# Access Compliance Report

## Public Rights-of-Way

### (Pedestrian Signals)

Intersection ID: N/A	Main Street:	Cross Street: N/A	Location: N/A
ADA ID: 54A7A64A16D4	Signal Type: One Push Button-Non APS	Overall Compliance: No	Severity Score: BTN 1: N/A BTN 2: N/A No BTN: N/A
Codes/Mitigation Info/Possible Solution		Field Measurements/Component Compliance

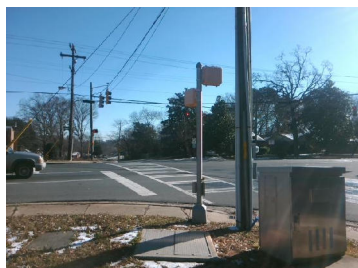
PROW/ADA: TMUTCD 4e.08, R404.3, R404.2

Yes	B 1 Clear Xing Direction?	ClearlyMarked	N/A	B 2 Clear Xing Direction?	N/A
	B 1 Crossing Direction	To NE		B 2 Crossing Direction	N/A
No	B 1 DistanceTo XWalk (in)	70.0	N/A	B 2 DistanceTo XWalk (in)	N/A
No	B 1 DistanceTo Curb (in)	73.0	N/A	B 2 DistanceTo Curb (in)	N/A
Yes	B 1 Diameter (in)	2.0	N/A	B 2 Diameter (in)	N/A

Possible Solutions: Replace Signal Push Button With APS Button on New Post. Remove & Relocate Sign.
